Attachment 2 to AEP:NRC:0894U

EXISTING TECHNICAL SPECIFICATIONS
FOR DONALD C. COOK NUCLEAR PLANT UNIT 2
MARKED TO REFLECT PROPOSED CHANGES

Attachment 3 to AEP:NRC:0894U

PROPOSED TECHNICAL SPECIFICATIONS
FOR DONALD C. COOK NUCLEAR PLANT UNIT 2

FIGURE 3.4-2

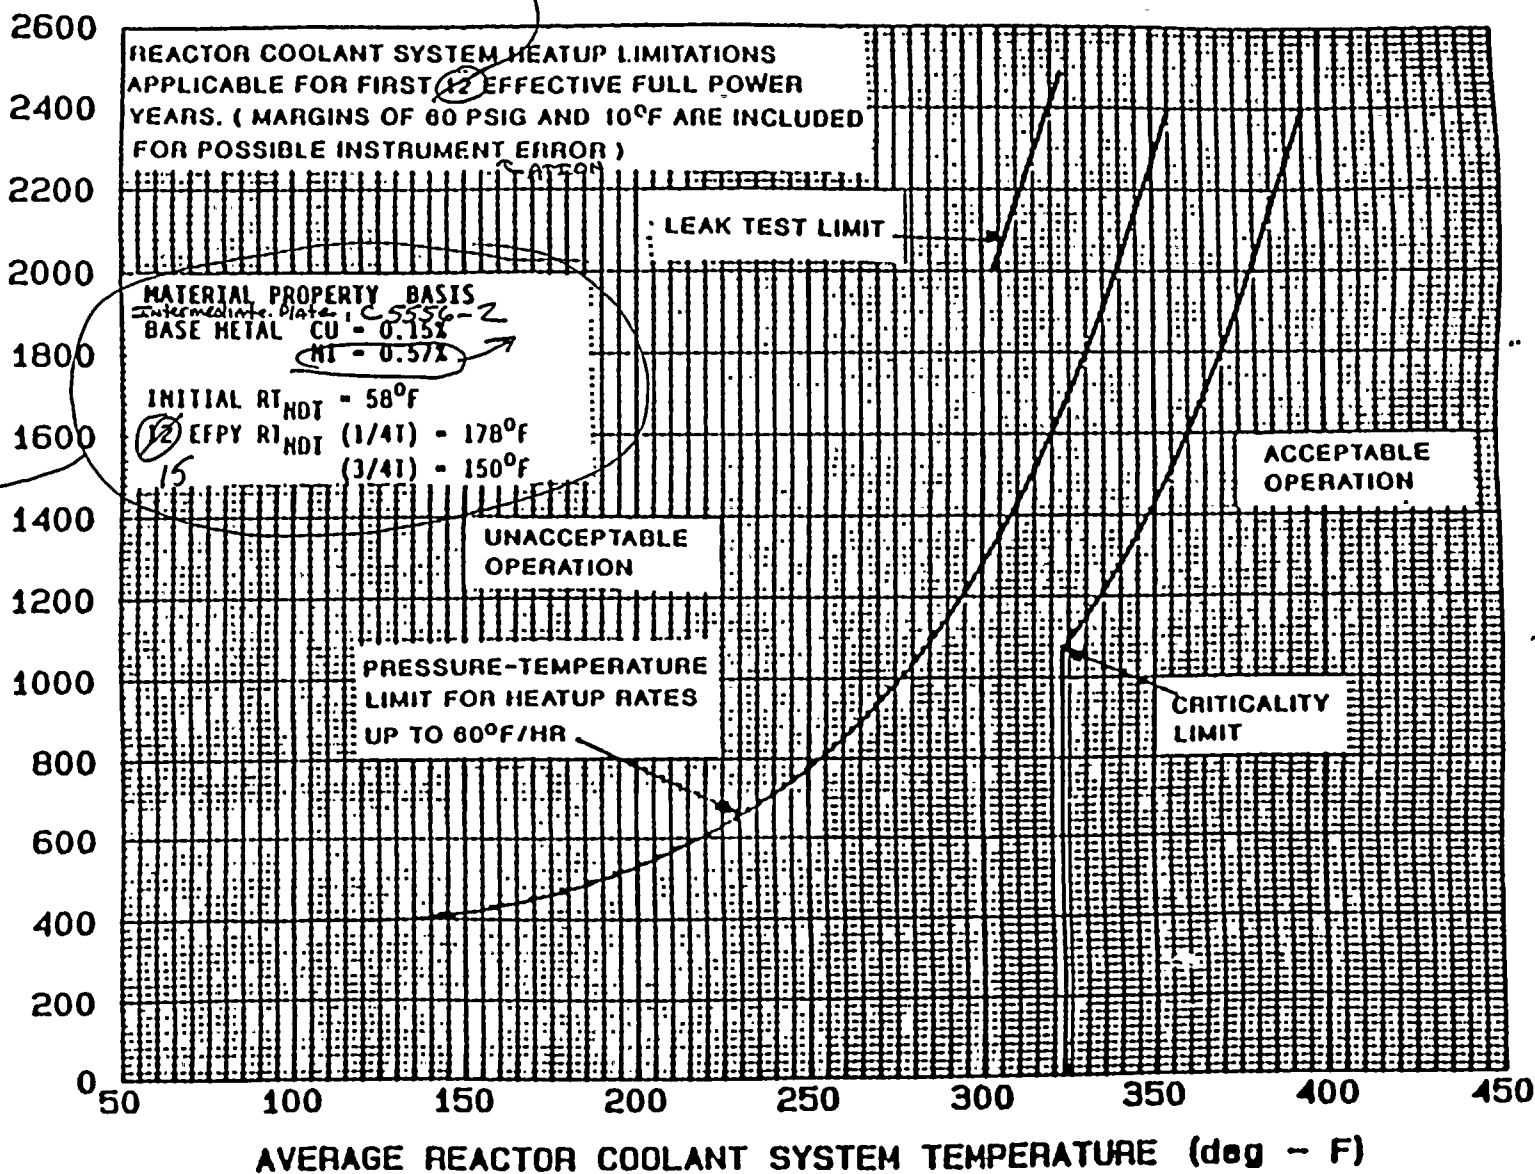
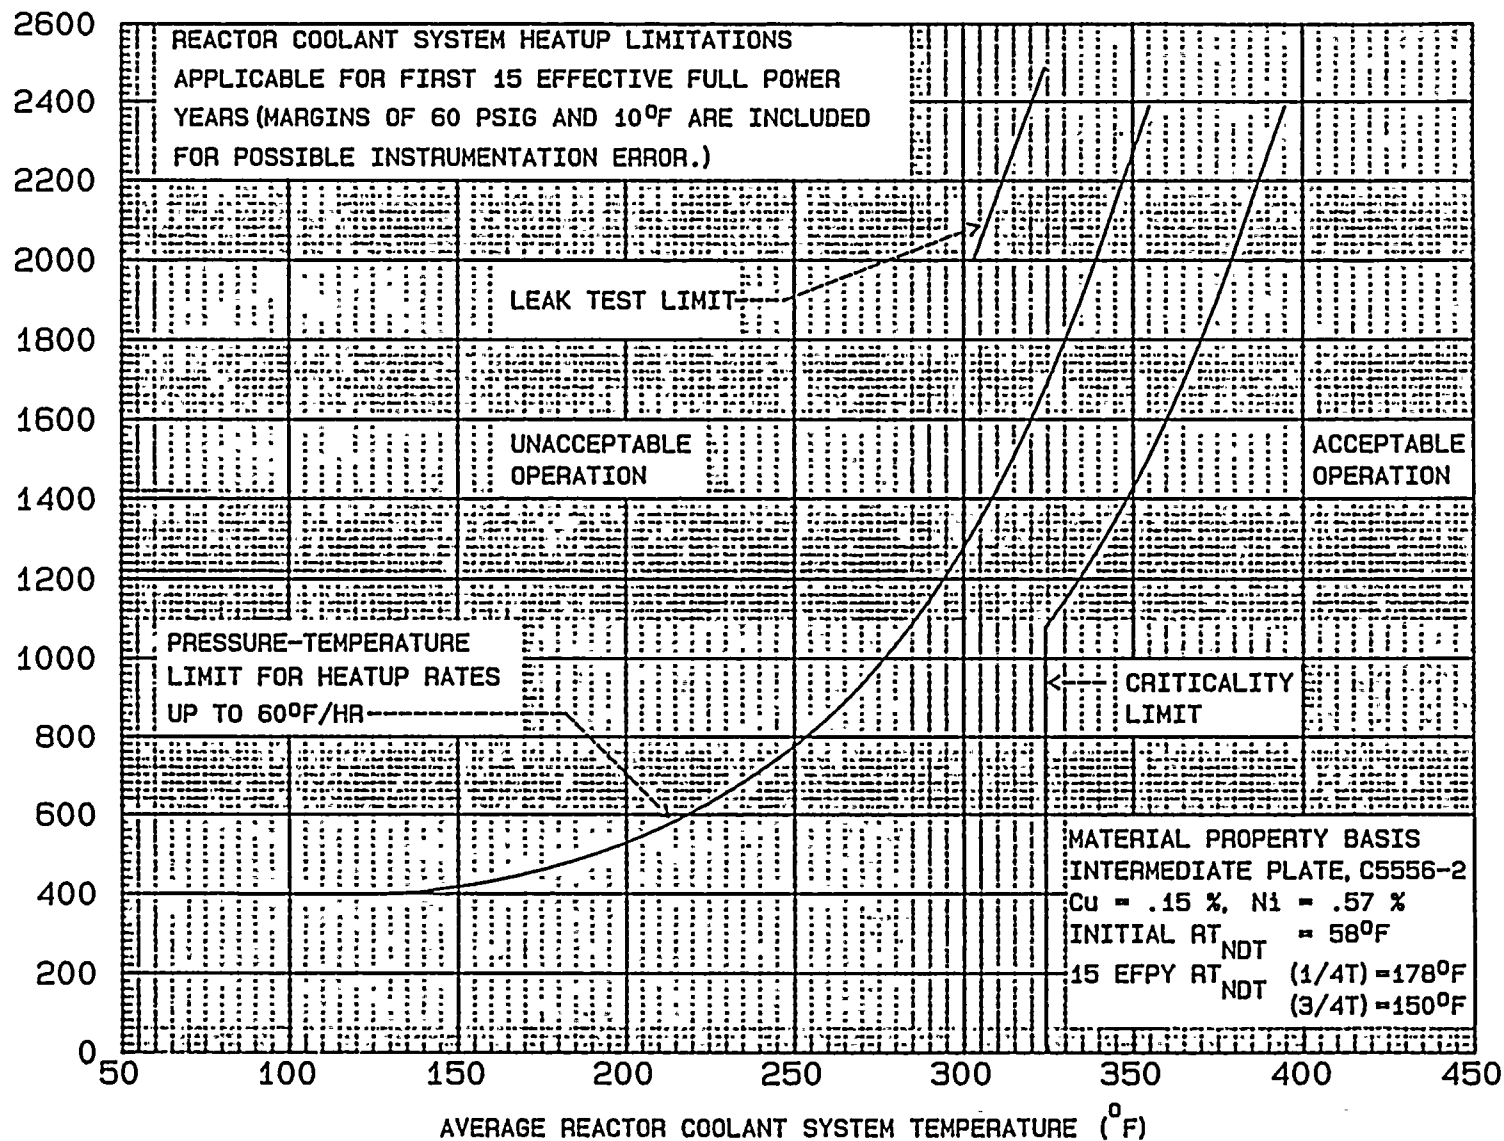
Move
to Bottom
Right
of Curve
w

The heatup limit curve, Figure 3.4-2, is a composite curve which was prepared by determining the most conservative case, with either the inside or outside wall controlling, for any heatup rate up to 60°F per hour. The cooldown limit curves of Figure 3.4-3 are composite curves which were prepared based upon the same type analysis with the exception that the controlling location is always the inside wall where the cooldown thermal gradients tend to produce tensile stresses while producing compressive stresses at the outside wall. The heatup and cooldown curves were prepared based on the most limiting value of the predicted adjusted reference temperature at the end of 12 EFPY.

The heatup limit curve, Figure 3.4.2, is a composite curve which was prepared by determining the most conservative case, with either the inside or outside wall controlling, for any heatup rate up to 60°F per hour. The cooldown limit curves of Figure 3.4-3 are composite curves which were prepared based upon the same type analysis with the exception that the controlling location is always the inside wall where the cooldown thermal gradients tend to produce tensile stresses while producing compressive stresses at the outside wall. The heatup and cooldown curves were prepared based on the most limiting value of the predicted adjusted reference temperature at the end of 15 EFPY.

The 15 EFPY heatup and cooldown curves were developed based on the following:

1. The intermediate shellplate, C5556-2, is the limiting material as determined by position 1 of Regulatory Guide 1.99, Revision 2, with a Cu and Ni content of 0.15% and 0.57%, respectively.
2. The fluence values contained in Table 6-14 of Westinghouse WCAP-13515 report, "Analysis of Capsule U From the Indiana Michigan Power Company D. C. Cook Unit 2 Reactor Vessel Radiation Surveillance Program", dated February 1993.

FIGURE 3.4-3

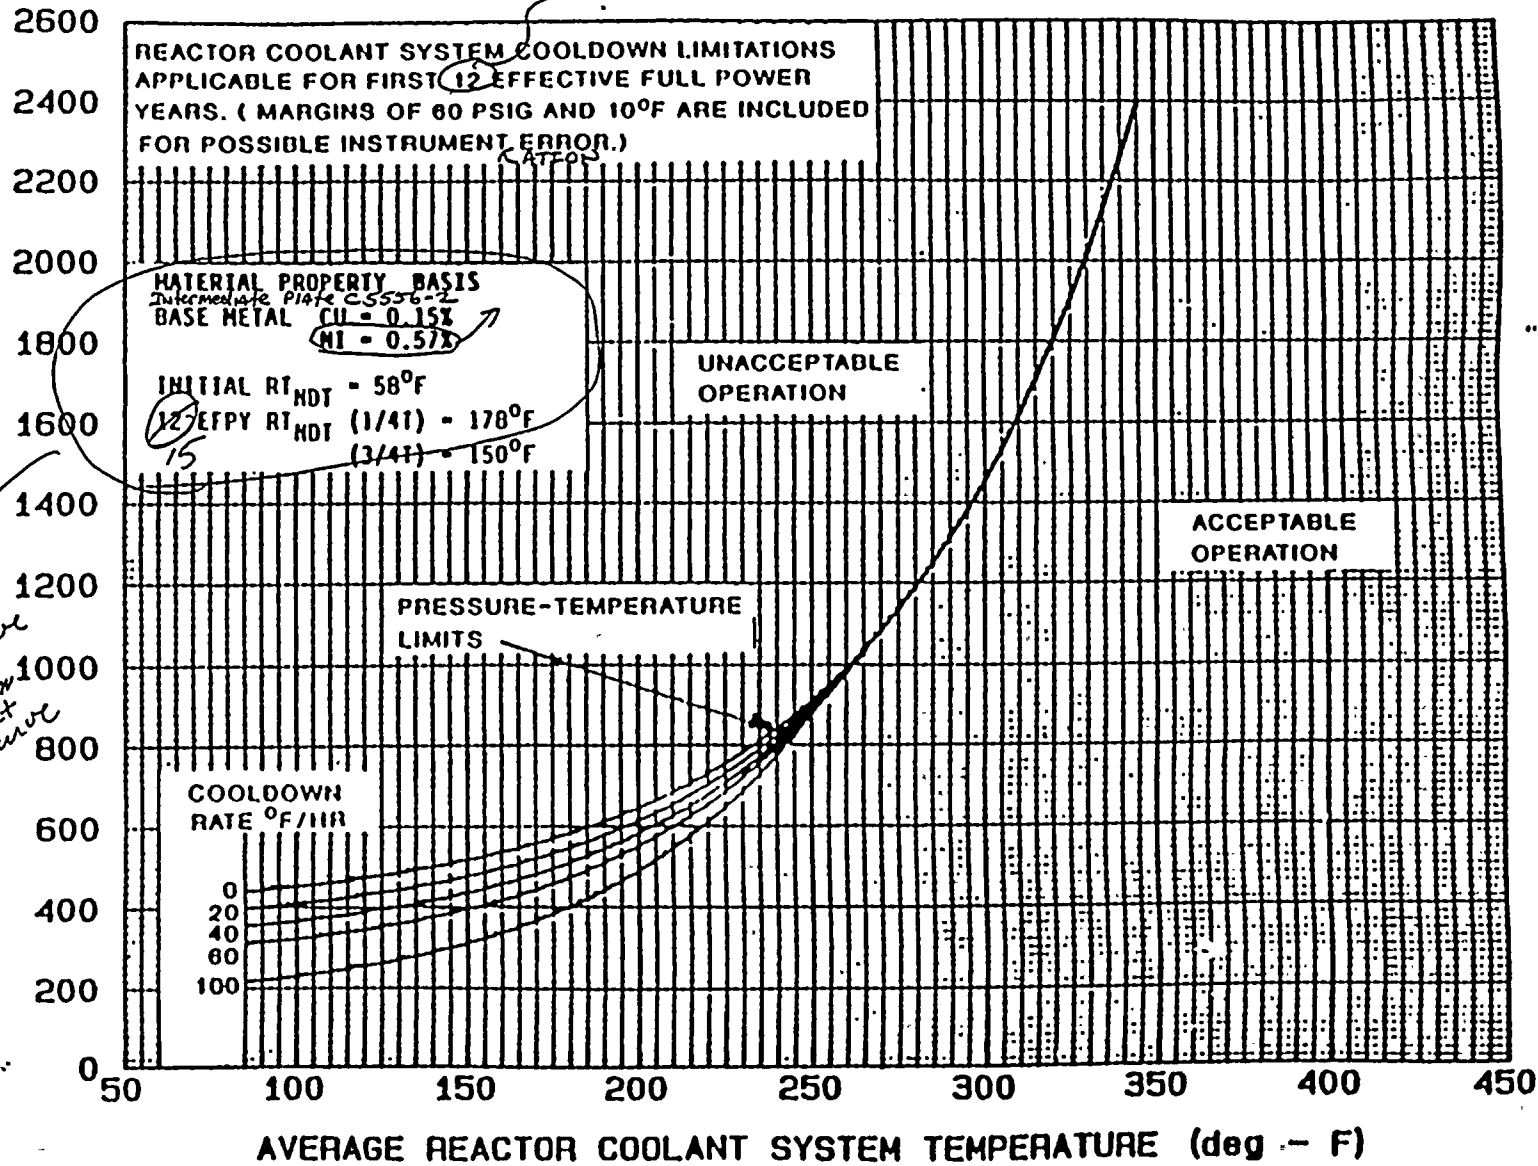
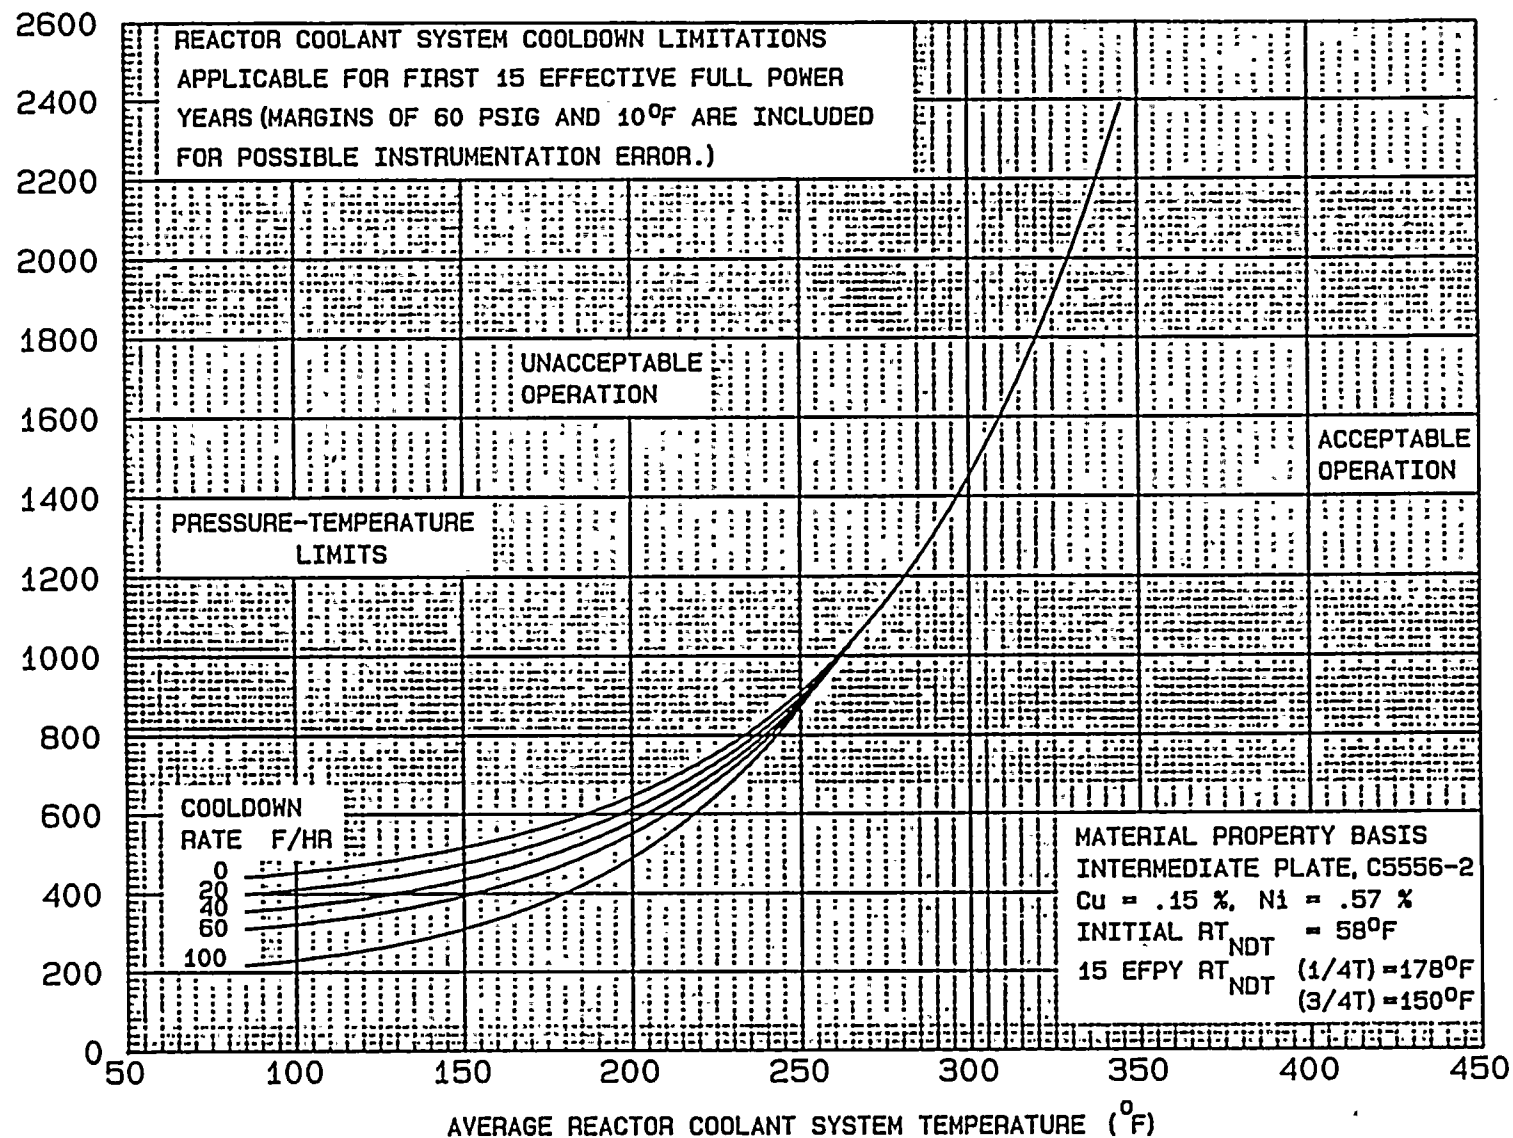
The heatup and cooldown limit curves of Figures 3.4-2 and 3.4-3 include predicted adjustments for this shift in RT_{NDT} at the end of 12 EFPY, as well as adjustments for possible errors in the pressure and temperature sensing instruments.

Insert No. 1 → The 12 EFPY heatup and cooldown curves were developed based on the following:

The heatup and cooldown limit curves of Figures 3.4-2 and 3.4-3 include predicted adjustments for this shift in RT_{NDT} at the end of 15 EFPY, as well as adjustments for possible errors in the pressure and temperature sensing instruments.
